ADDITIONAL SUPPLEMENTARY REPORT - 2014SYE025 (DA-24/2014)

Property: 195 Lakemba Street and 3-5 Hampden Road, Lakemba
Lot 1 DP 597005 & Lots 11A and 11B DP 6712

Proposal: Construction of a mixed use development involving the demolition (in part) of existing structures and the construction of three (3) buildings comprising of four (4) retail/commercial units, 89 residential units, basement parking, landscaping works and associated stratum subdivision

Figure 3: Proposed changes - southern elevation of Building A

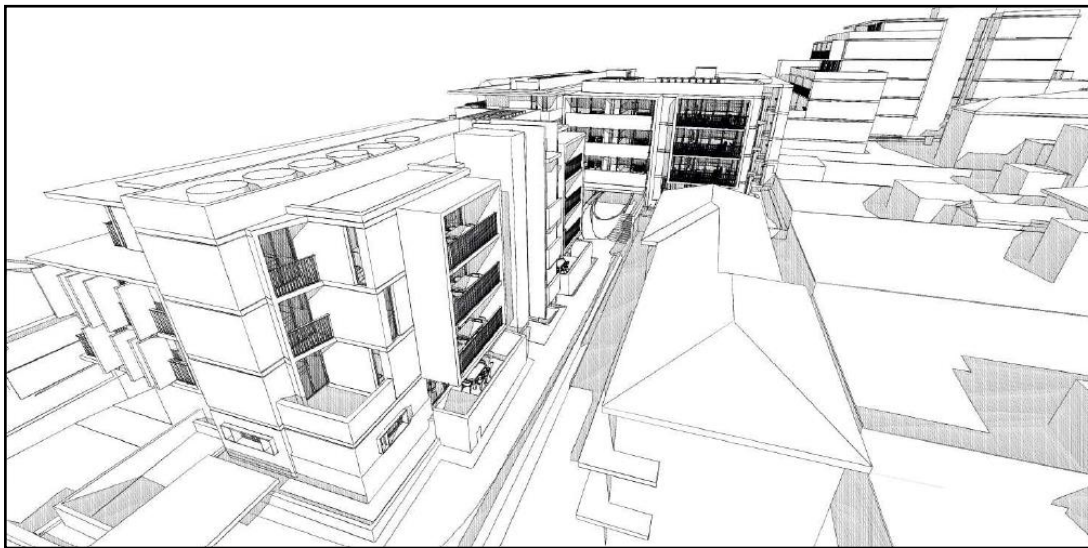
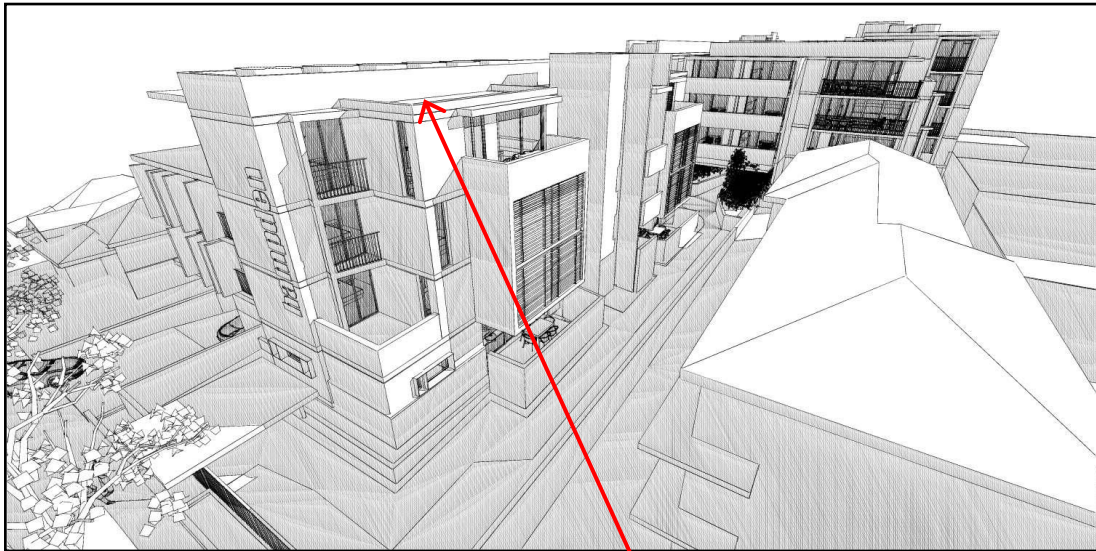
Referring to Figure 2 above, this shows the existing southern elevation of Building A. In comparison, Figure 3 on the following page provides an image of proposed minor amendments to the southern elevation of Building B showing removal of the balcony roof at the topmost level and provision of privacy screens to the second and third levels.

Referring to Figure 3 on the following page, we have provided an image which removes the covered component to the topmost level of each balcony. In addition we have provided privacy screens to levels two and three where there is an interface with No.1 Hampden Road. Privacy screens are not provided to

Therefore as Figure 3 demonstrates, in terms of amenity, there is no additional impact created by keeping these balconies in this location given there is no additional shadow created by the balcony elements along this elevation. The shadow cast is from the top of the parapet wall above Bedroom Two. Therefore, even if we were to comply with the condition as suggested by Council, this element would cast the same shadow onto No.1 Hampden Road, which is no different to Figure 3 above and hence our request to retain these balconies.

By way of note, the Residential Flat Design Code does allow for building separation distances to be varied, provided daylight access, urban form, visual and acoustic privacy has been satisfactorily achieved. As noted in this letter, based on changes depicted in Figure 3 overshadowing is reduced to No.1 Hampden Road, noting that urban form, visual and acoustic privacy has also been satisfactorily achieved. Therefore the fine tuning of the design along the southern elevation of Block A is considered appropriate.

- In regard to the unnumbered condition before Condition 160 (now Condition 1[n]), relating to the deletion of the balconies of Units A4.01, A4.05, A5.01, A5.05, A6.01 and A6.04 and changing the 'B2' rooms in each of these to become balconies, the applicant has provided a revised design which removes the covered component to the topmost levels of the balconies for Unit A6.01 and A6.04 and has proposed to install privacy screens to the balconies of the lower units being Unit A4.01, A4.05, A5.01, and A5.05. The measures proposed by the applicant aim to address the shadowing and privacy impacts raised as part of the assessment of the original design. It is accepted that the revised design helps to improve access to sunlight to the adjoining property at 1 Hampden Road and minimise privacy impacts between existing and future adjoining neighbours. In this regard, it is recommended that the unnumbered condition before Condition 160 (now Condition 1[n]) is to be deleted. It is noted however, that despite comments made by the applicant that no privacy screens should be required for the two top units (being Unit A6.01 and A6.04), it remains our recommendation that privacy screens should be installed given that there would still likely be views from these balconies onto adjoining balconies (see point below).

- In regard to Condition 160 (now Condition 1[o]) relating to the balconies for Units A4.01, A4.05, A5.01, A5.05, A6.01 and A6.04 and requiring the installation of privacy screens, it is considered appropriate to maintain this condition as it is given that it aims to protect the privacy of the existing residents of 1 Hampden Road and future residents of the subject Building A. The recommended privacy screens will minimise privacy impacts between balconies that will be directly opposite the north facing balconies of 1 Hampden Road. In this regard, Condition 160 (now Condition 1[o]) is to remain as it is.
